NUMBER: 23-025-07

Rear Seat Back May Not Fold Due To Latch Release Cable Loose At Handle

2007 (JK) Wrangler

Fig. 1 SEAT BACK RELEASE HANDLE / CABLE

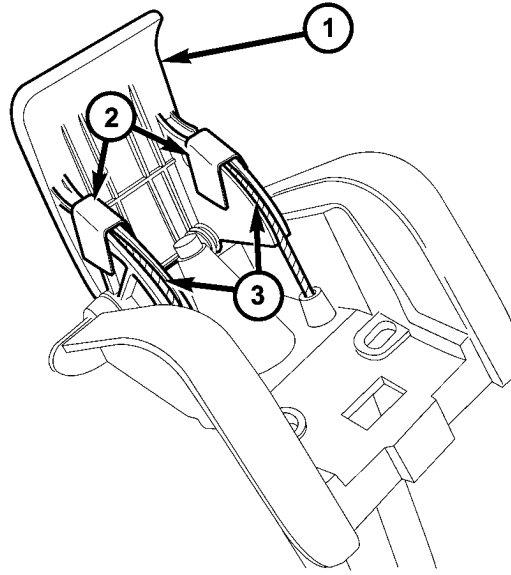
The customer may not be able to unlatch the seat back on the rear seat. This condition may be due to the rear seat back latch release cable. The lug on the end of the release cable may come free of the release handle.

On the suspect seat back, raise the seat back release handle and determine if the release cable end lug is properly engaged to the release handle. If the release cable end is not engaged correctly to the release handle then perform the Repair Procedure.

1. Perform this repair to both rear seat back release handles, for the 60% and the 40% seat backs.
2. If rear seat has a 60/40 split seat back (two handles), then cut three (3) 13 mm x 40 mm (0.5 in. x 1.5 in.) tape strips from the larger piece of nylon flock tape. If rear back has a single seat back (one handle), then cut two (2) 13 mm x 40 mm (0.5 in. x 1.5 in.) tape strips from the larger piece of nylon flock tape.
3. For each rear seat back release handle (two handles on the 60/40 rear seat), install tape over each release cable end lug (Fig. 1).
4. Verify that the tape is fully seated on both release handles.
